**DIRECT TESTIMONY  
OF  
HYDE M. MERRILL  
ON BEHALF OF  
PIEDMONT ENVIRONMENTAL COUNCIL  
BEFORE THE  
STATE CORPORATION COMMISSION OF VIRGINIA  
CASE NOS. PUE-2007-00031 AND PUE-2007-00033**

Figure 6

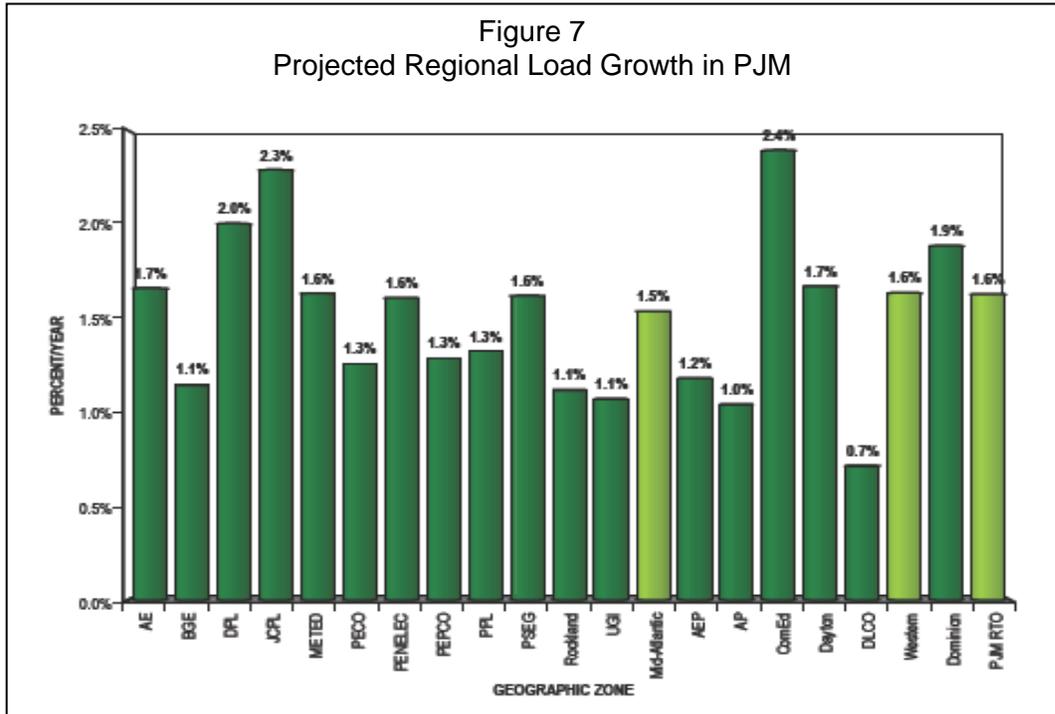
8 Northern Virginia demand is only 19% of the load and increase in load that, according to  
9 PJM, the Loudoun line would serve. See Figure 6.

10 Northern Virginia’s share of the regional load is even less than what Figure 6 shows.  
11 That exhibit excludes Allegheny Power customers in Northern Maryland who are served from  
12 the Doubs and Bedington substations and who would be served in part by the Loudoun line,  
13 according to PJM. The KEMA report indicates that the demand of the Allegheny Power  
14 customers in Northern Maryland might amount to about 2,200 MW. Using KEMA's numbers ,  
15 Northern Virginia demand falls to 18% of the load to be served by the Loudoun line.

Figure 10  
 Generation interconnection study queues are growing, but especially dramatically in eastern PJM

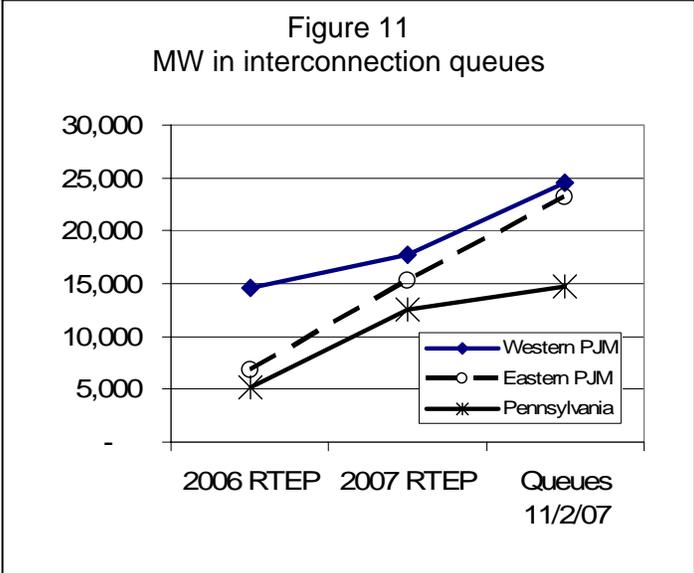
7 A: Yes, it is. See Figure 10 and Figure 11. See Exhibits HMM-8, HMM-33 and HMM-34.

Figure 20

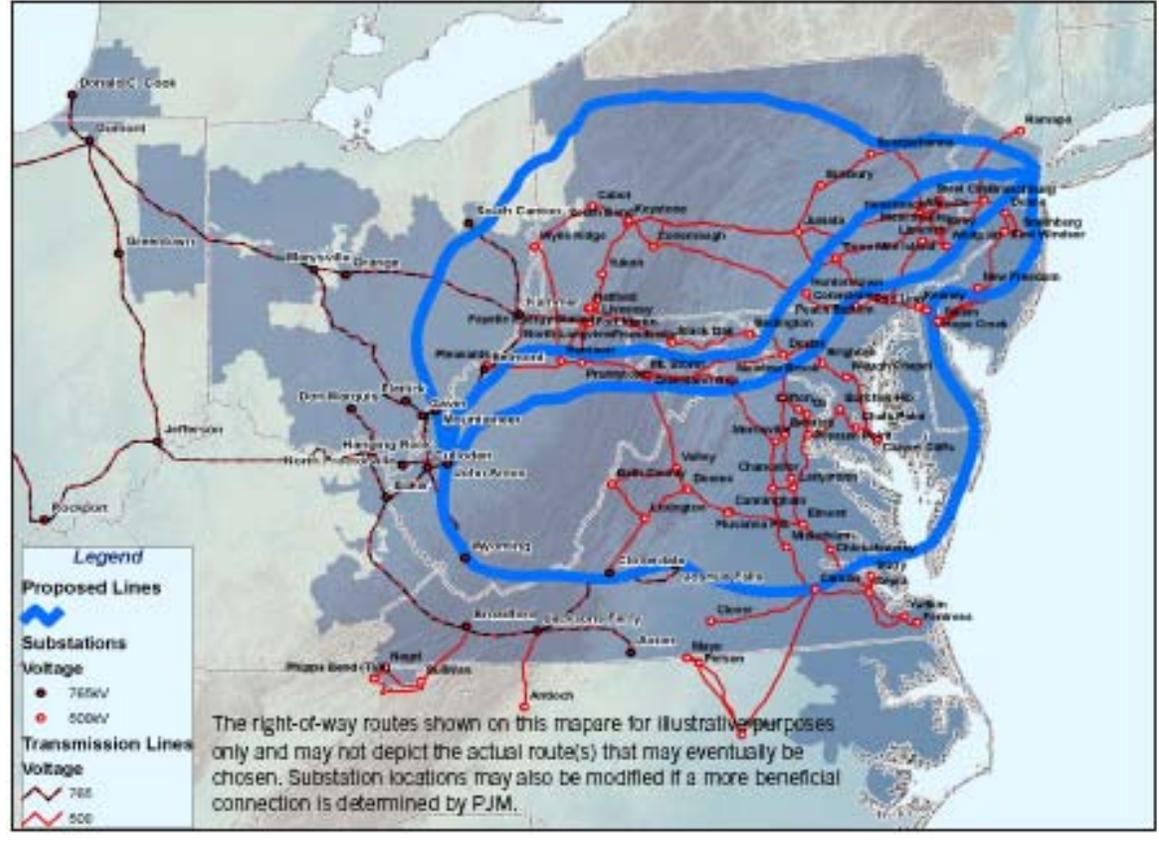
The blue lines are the “Project Mountaineer” concept from the 2005 Pfirmann presentation. The Loudoun line is essentially the western half of one of the two central lines. The Amos-Kempton 765-kV project, announced in 2007, is half of the other. PJM also has announced plans to build a portion of the southern blue line that crosses the Chesapeake Bay and runs north through Delaware into New Jersey.

This is all being done unilaterally and piecemeal, without anyone except PJM accepting or endorsing PJM’s overall strategic plan.
